URBAN DESIGN BRIEF

601 LAURIER AVENUE

21 MARCH 2025

Response to UDRP Comments

View Looking North

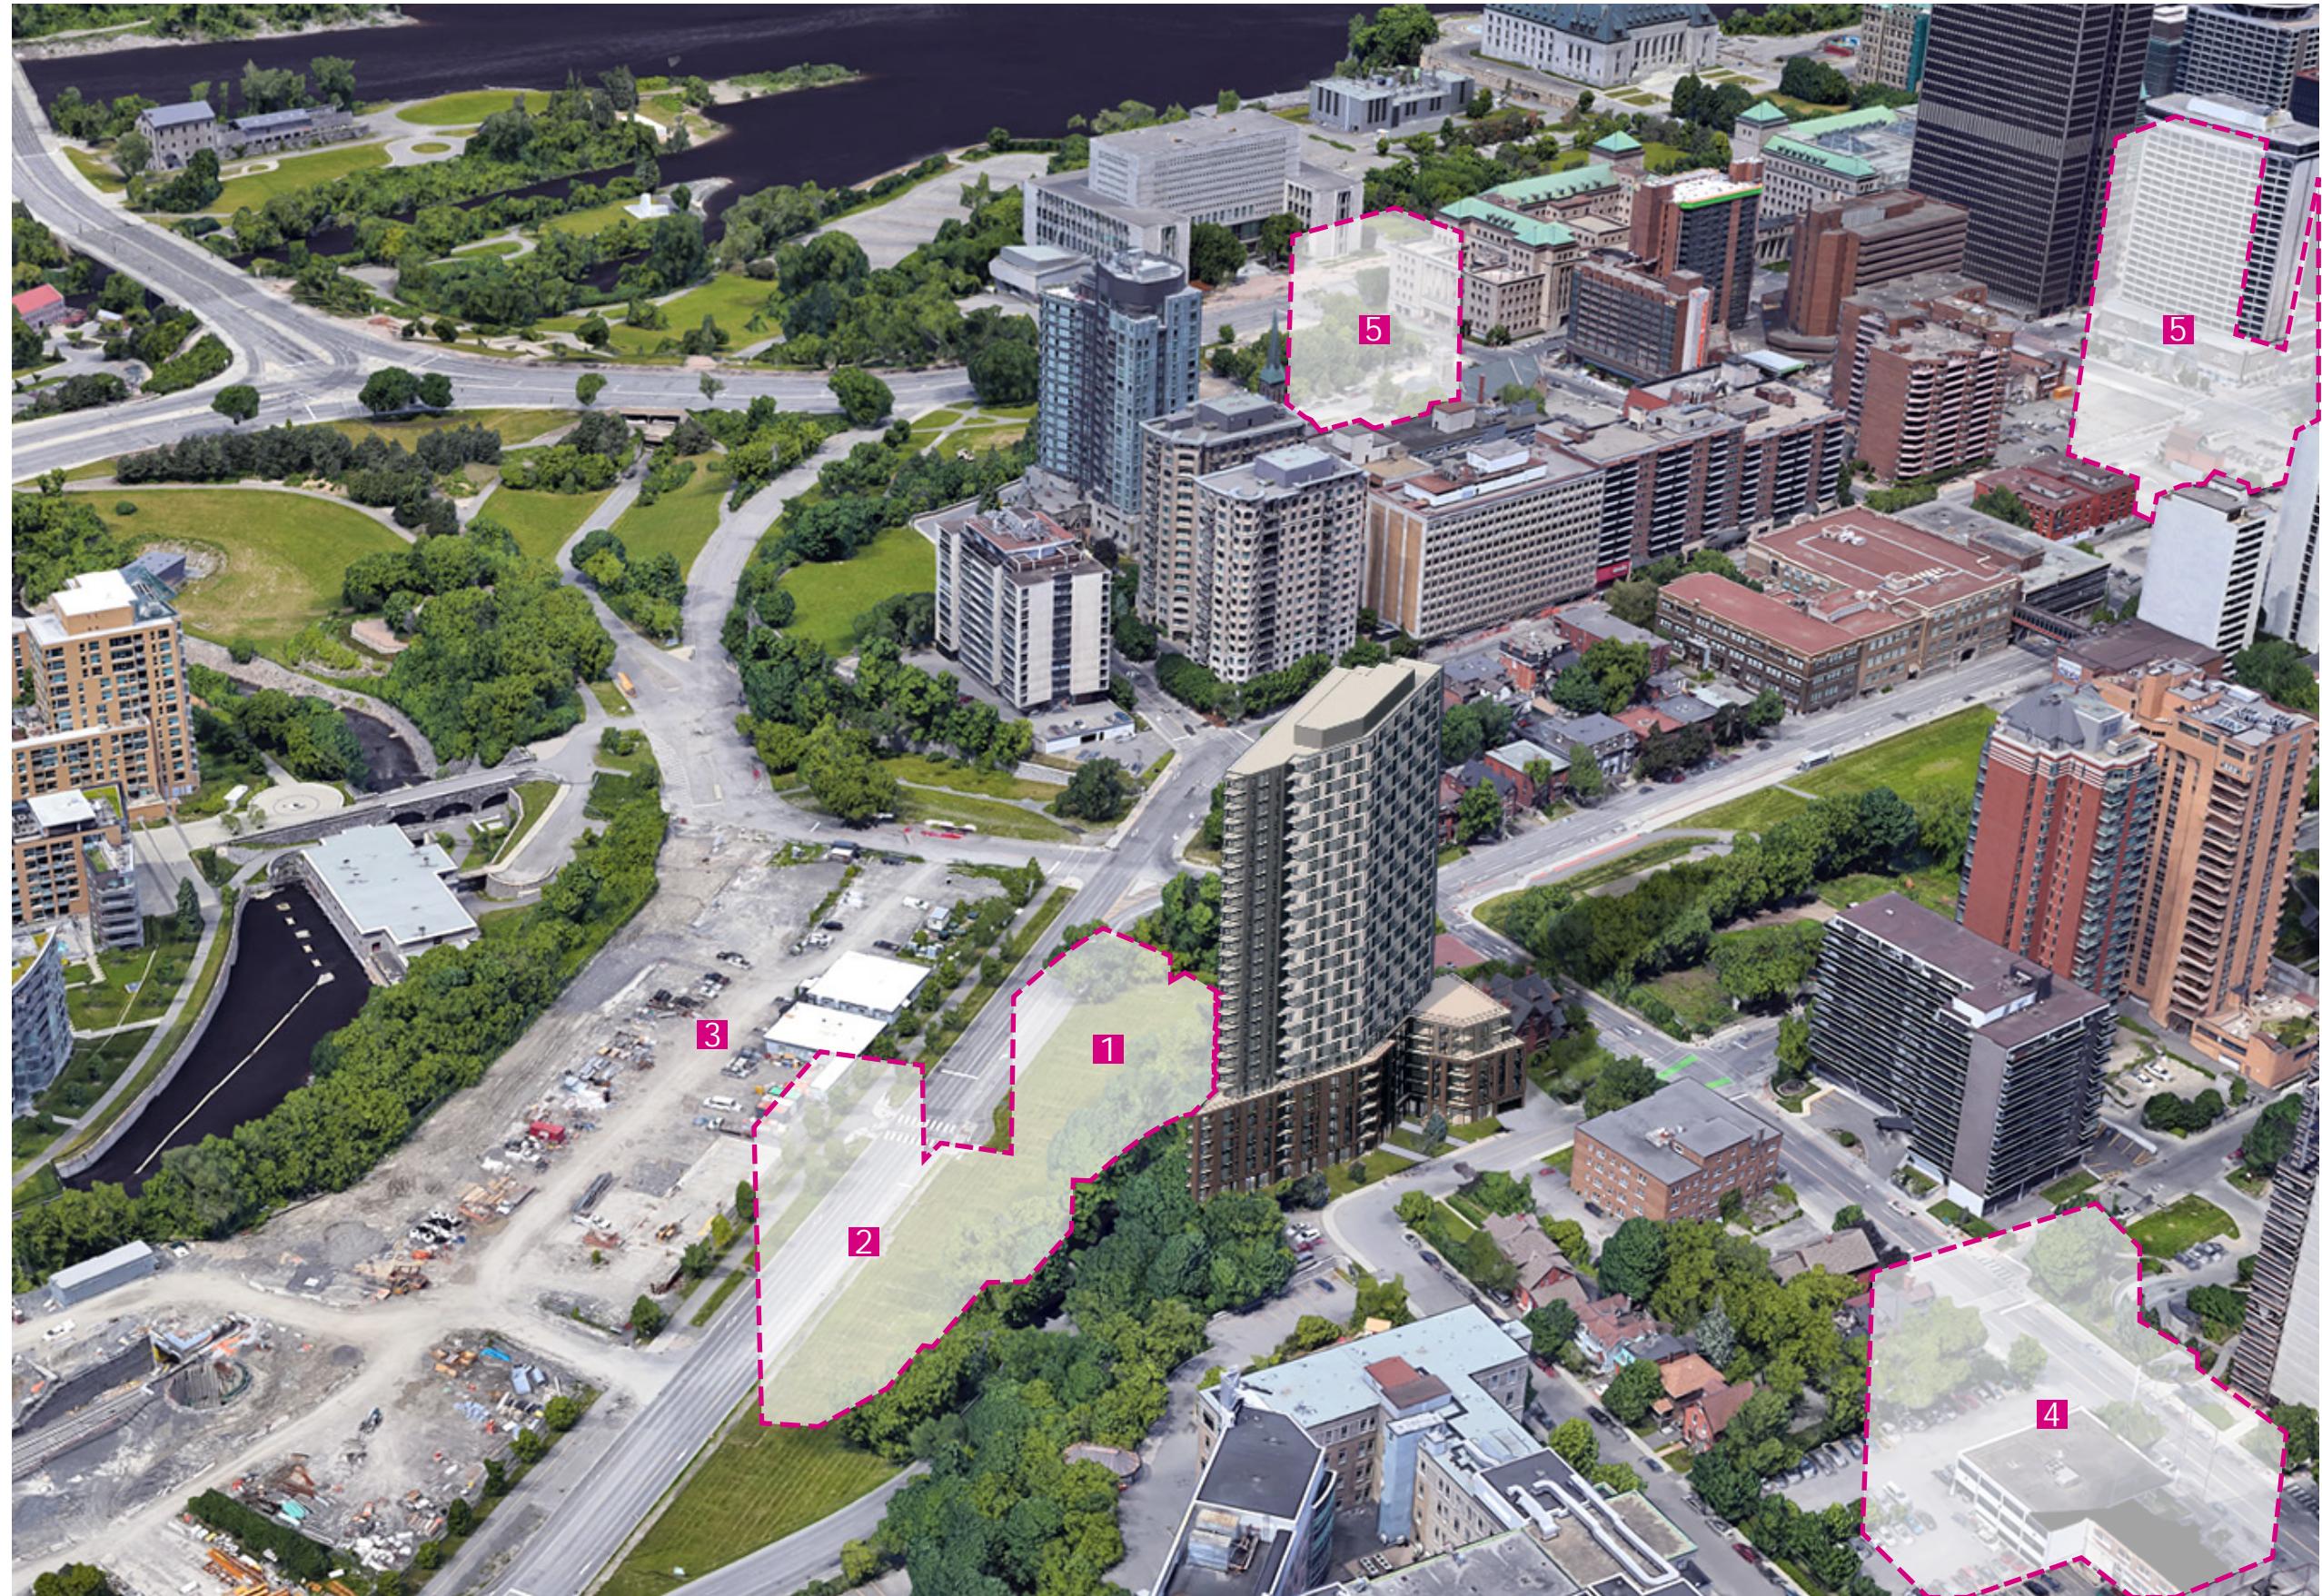
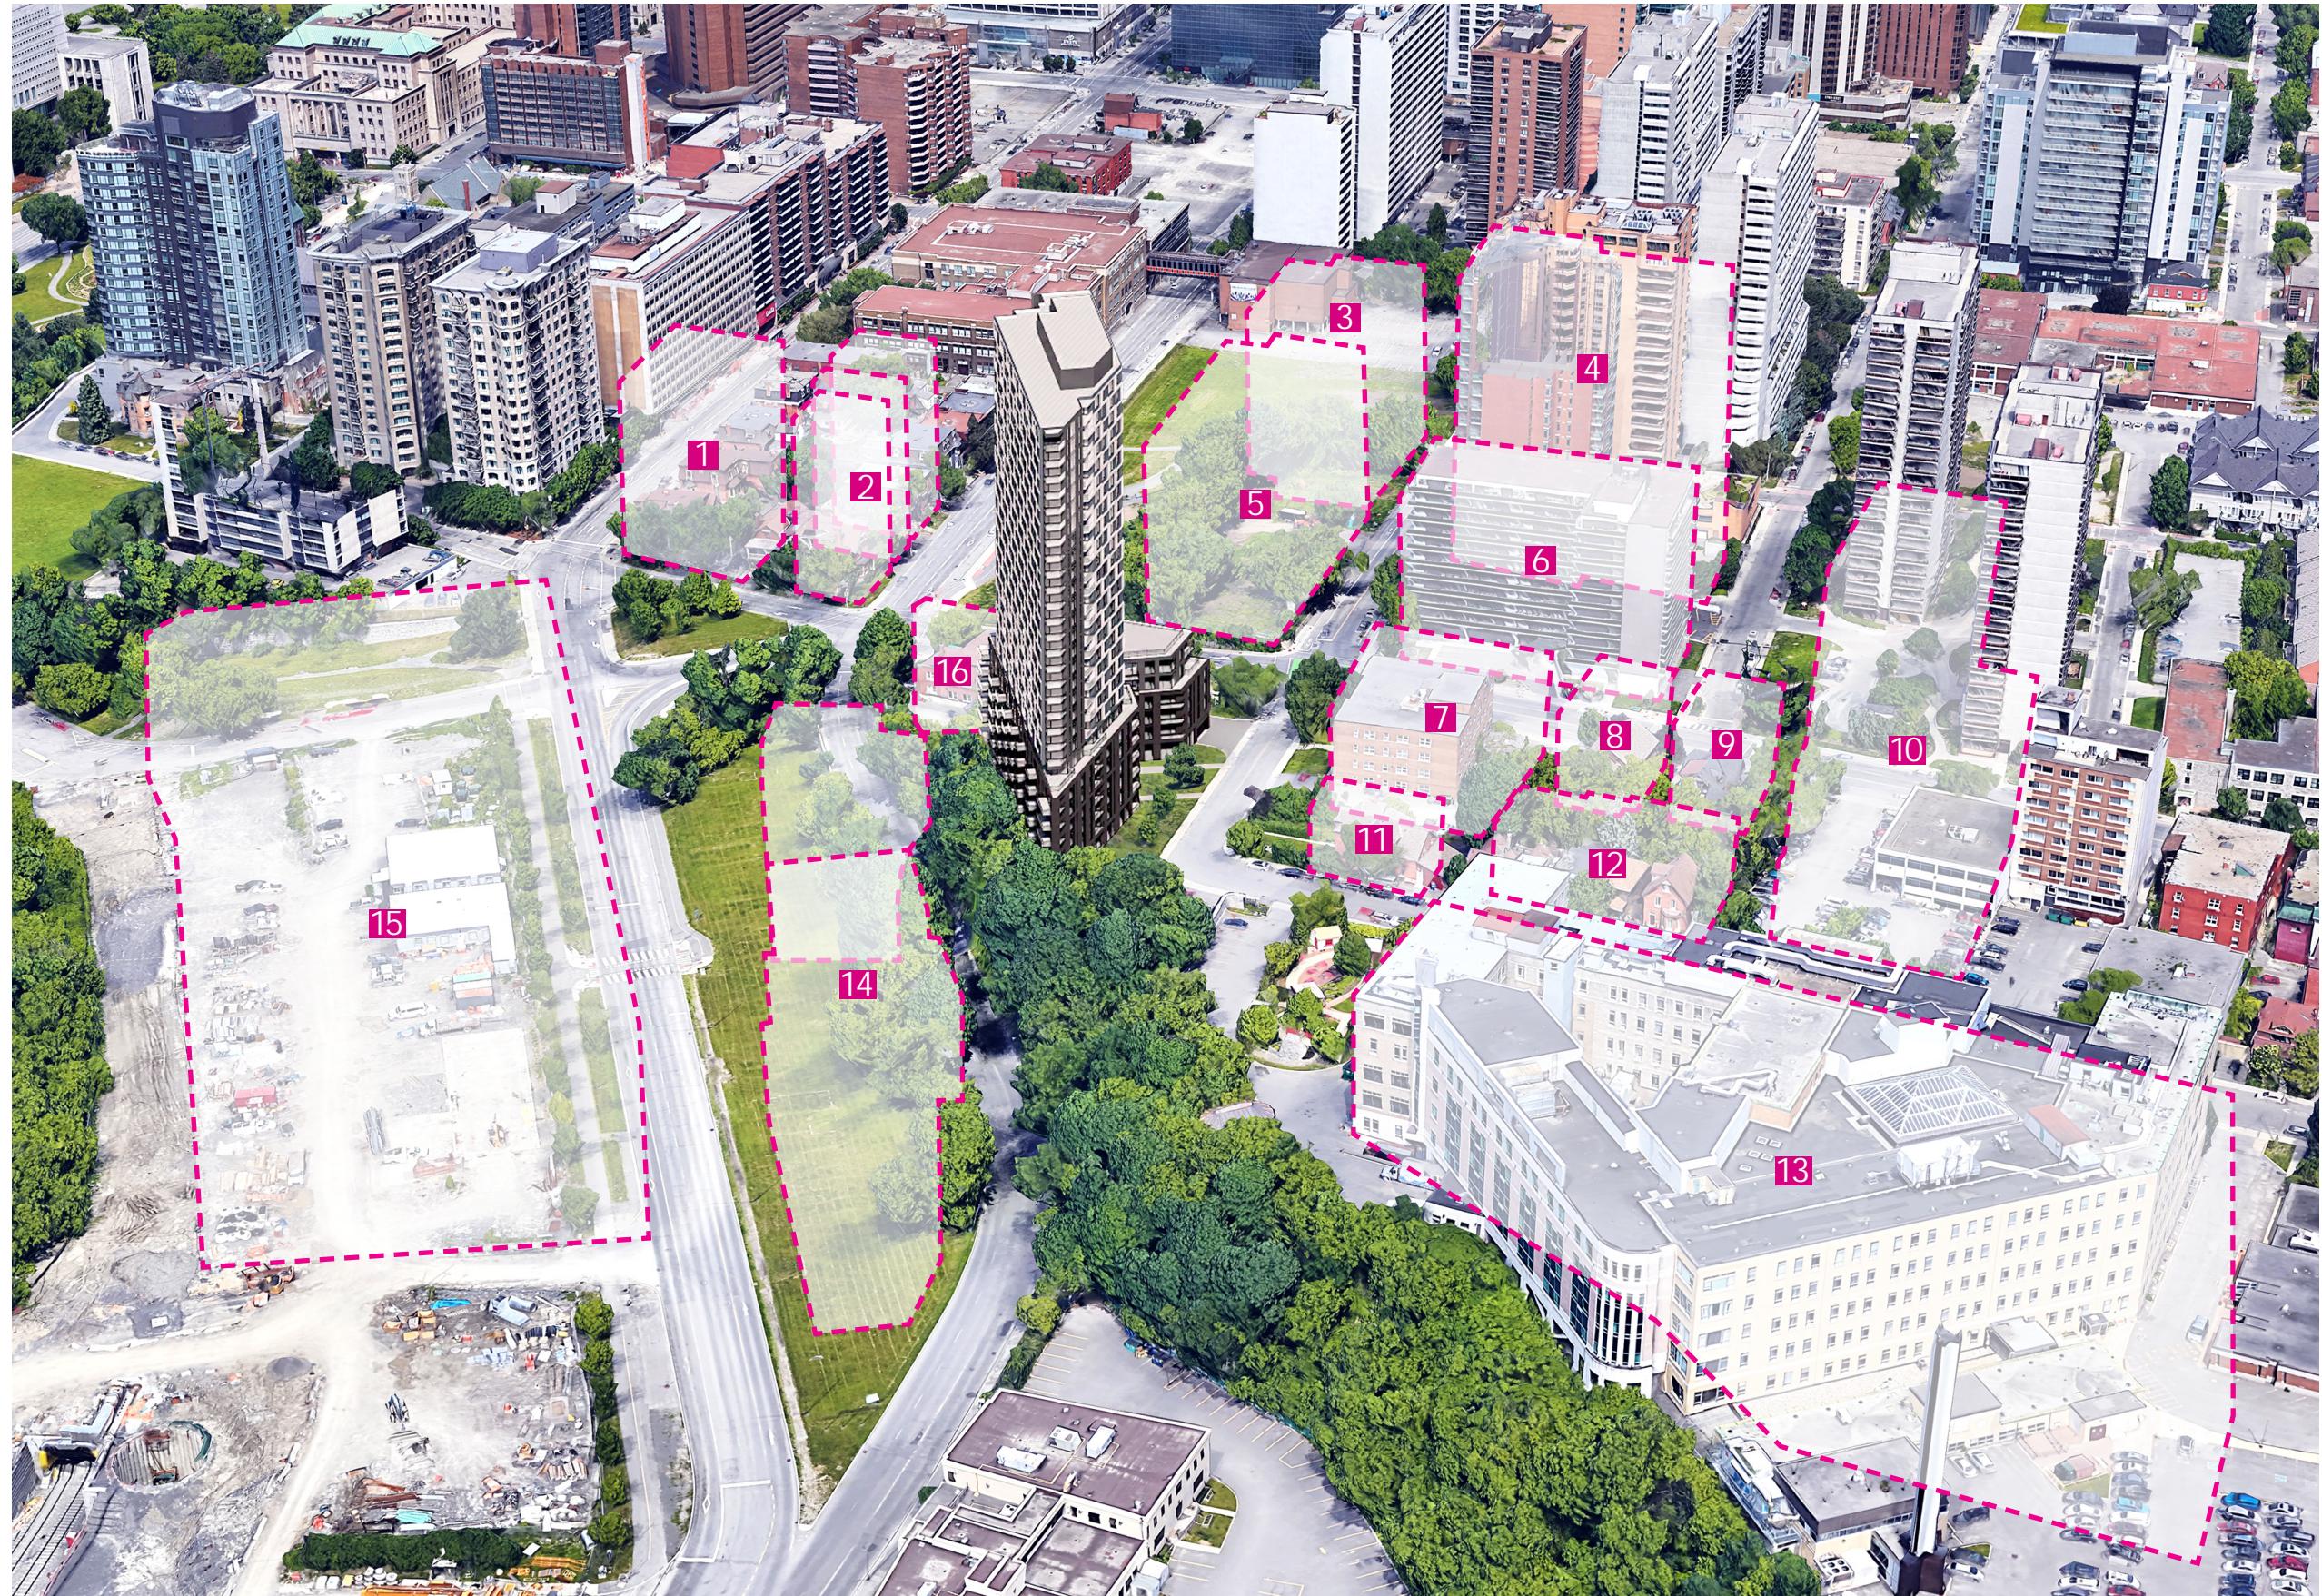
We recommend providing massing of the project and its context to better understand the future relationship to the existing context of the surrounding properties and their planned context. Be sure to include the properties down the escarpment and along Cambridge, Laurier, Bronson and where Slater has been removed.

We have provided material illustrating the massing of the project and its context, showing the relationships with the escarpment and surrounding properties. This includes properties down the escarpment and along Cambridge, Laurier, Bronson, and the area where Slater has been removed. These visuals help to better understand the future relationship to the existing and planned context of the surrounding area.
